## Technical Note 1

### Land to the east of St Nicholas - Planning Ref: 2016/00619/FUL

2. This Technical Note has been produced in response to comments received from the Vale of Glamorgan's (VoG) Highway Officer (dated 20<sup>th</sup> July 2016), in relation to the proposed site access options. These comments are contained in **Appendix A**.

## Vale of Glamorgan Highway Authority Observation Sheet

**Swept Path Analysis using an 11m Pantechon Vehicle**

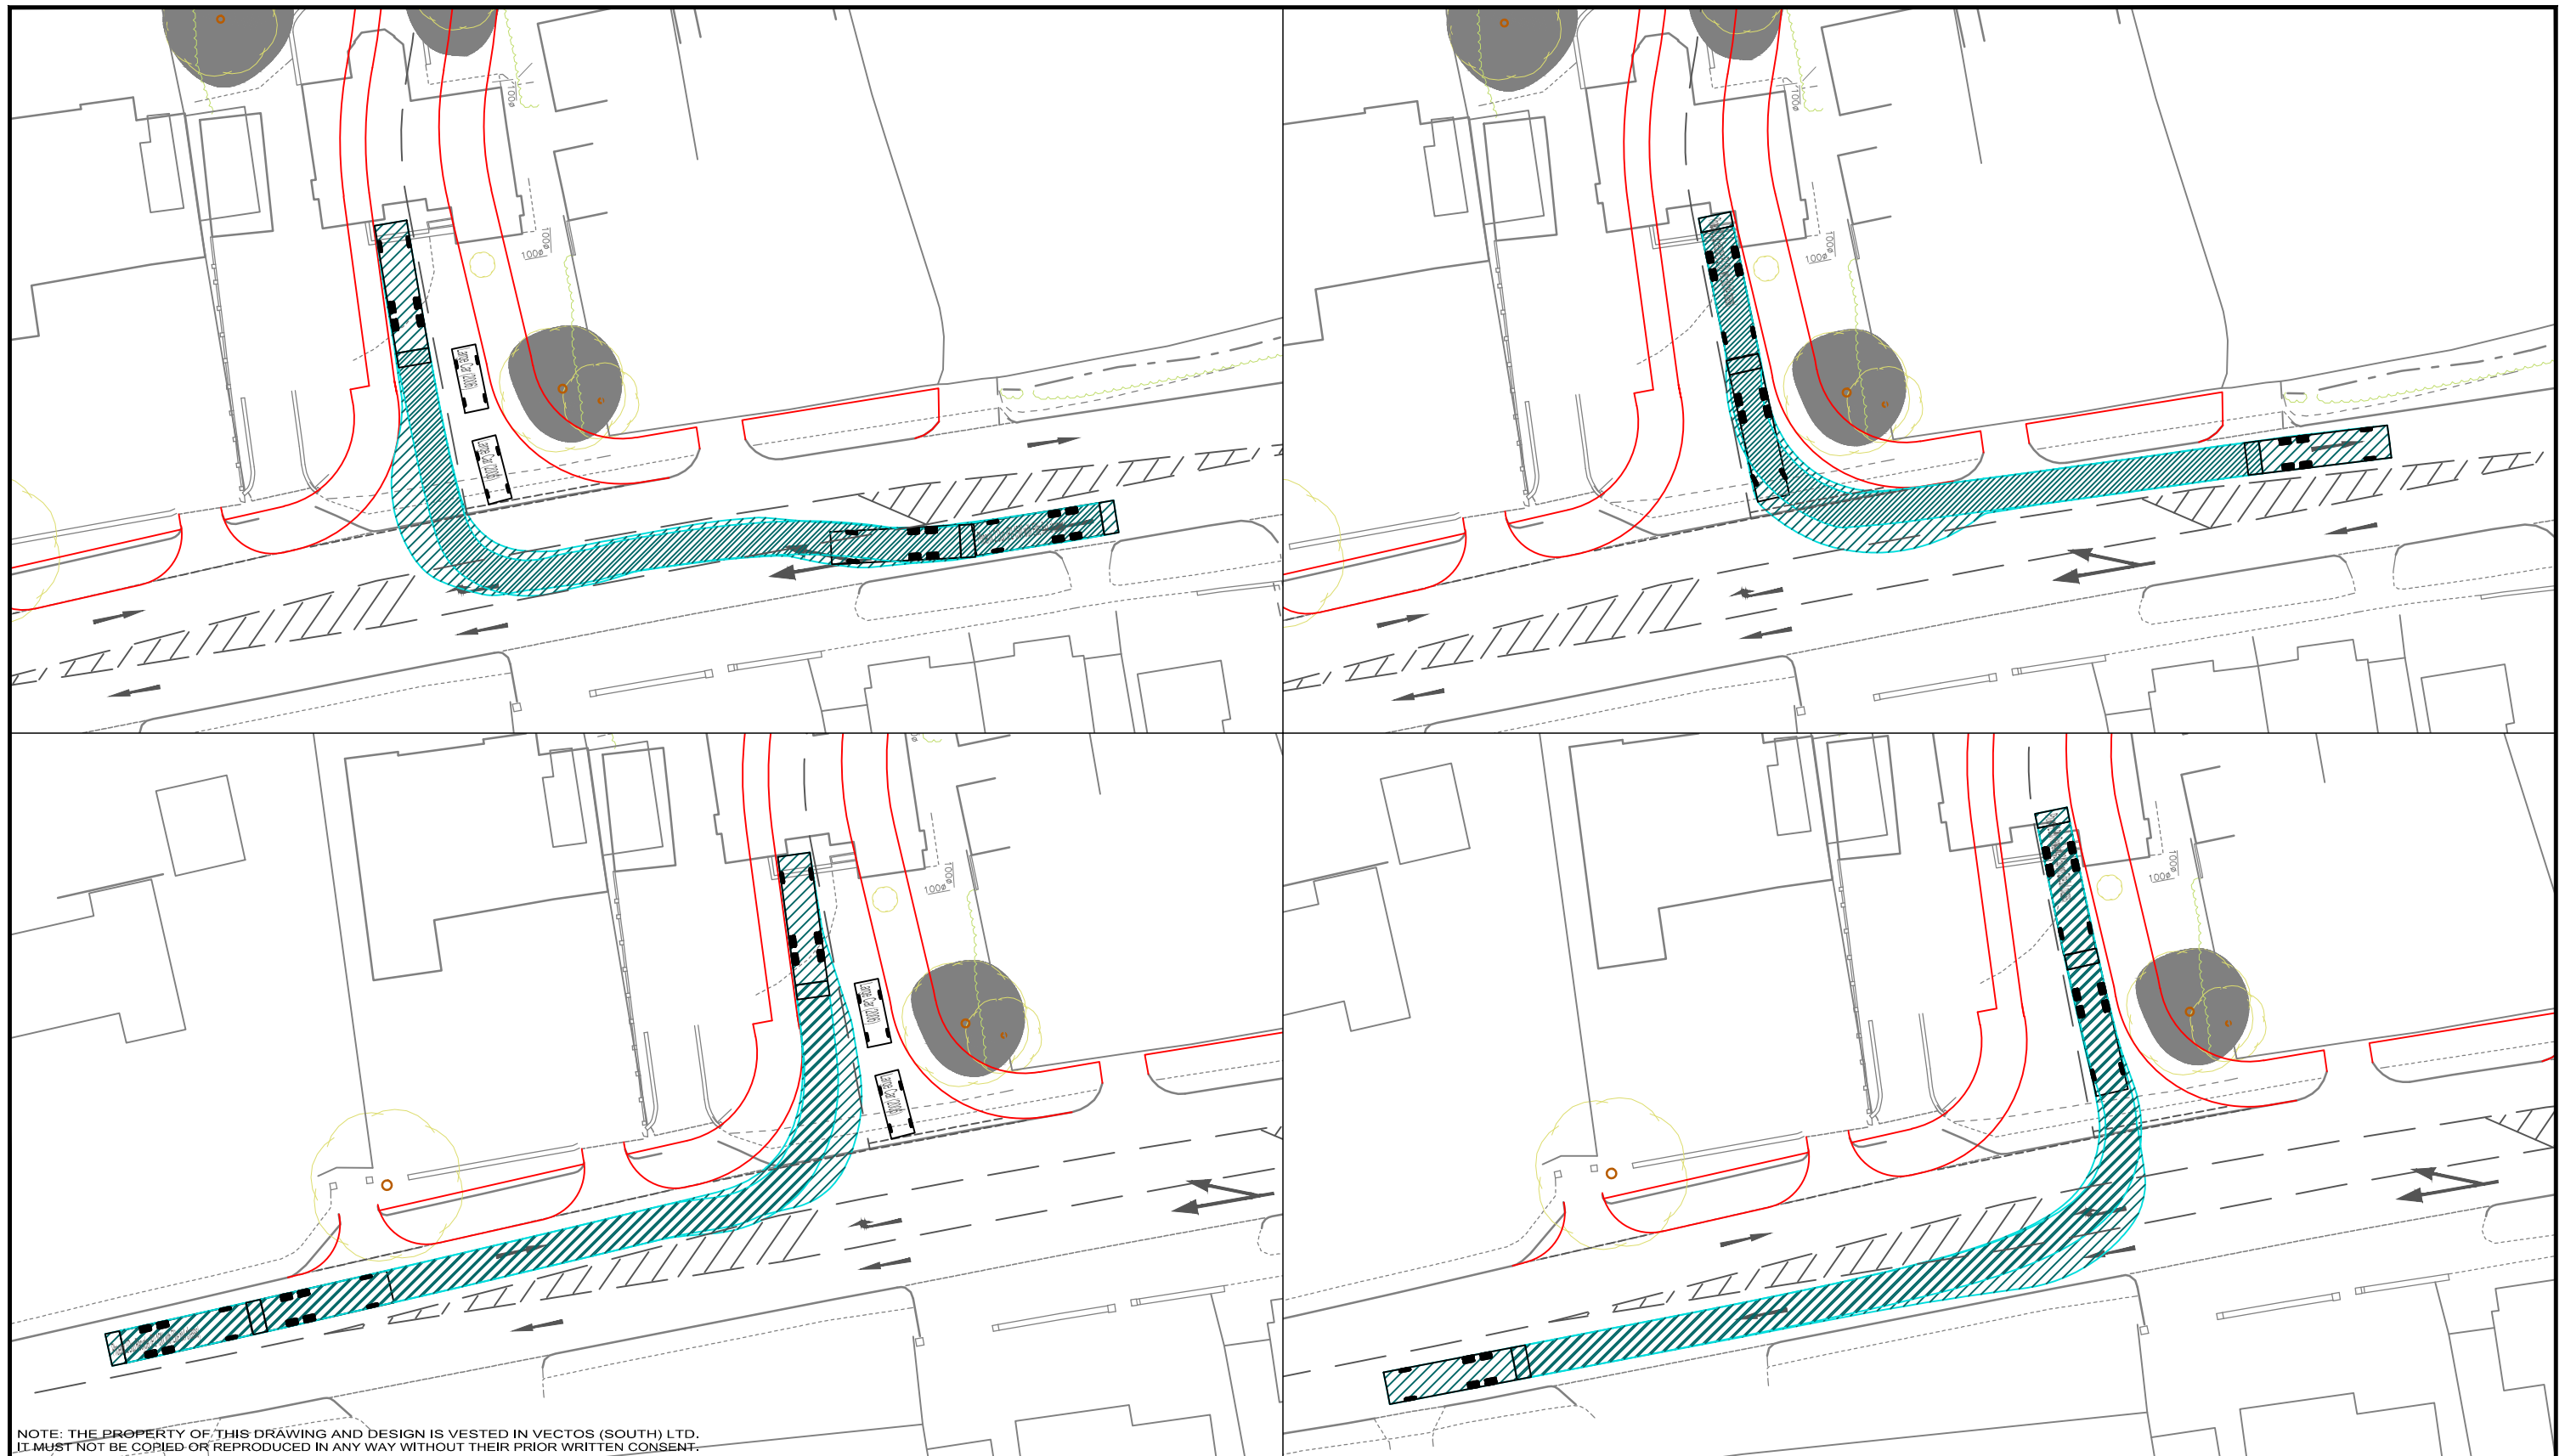
In terms of the access arrangements configuration, the Highway Authority would advise that the proposed junction radii onto the A48 for the development access of 6 metres is **not** deemed suitable at this location where there is occasional use by large goods vehicles such as refuse vehicles and removal/ delivery vehicles.

1. The junction radii being increased to 10.5 metre ( minimum)
2. The access width being 5.5m
3. Visibility Splays 100m x 4.5m in Both Directions based on the Desirable Minimum Safe Stopping Distance and reduction to the absolute Minimum o SSD of 80m will need justification.
4. Submission of comprehensive swept path analysis of the junction area allowing for the movements of 11m ridged vehicles entering / exiting the site while there is a vehicle sighted at the minor arm junction.

- (Plan H02) - A pantechnicon removals lorry (11m in length) does cross in to the opposing lane when entering the site. However, this type of vehicle would only visit the site infrequently and even when it crosses in to the opposing lane, it does not conflict with any vehicles queued on the minor arm, waiting to exit the site. As such this is considered an acceptable approach for such a large vehicle that would visit the site infrequently;
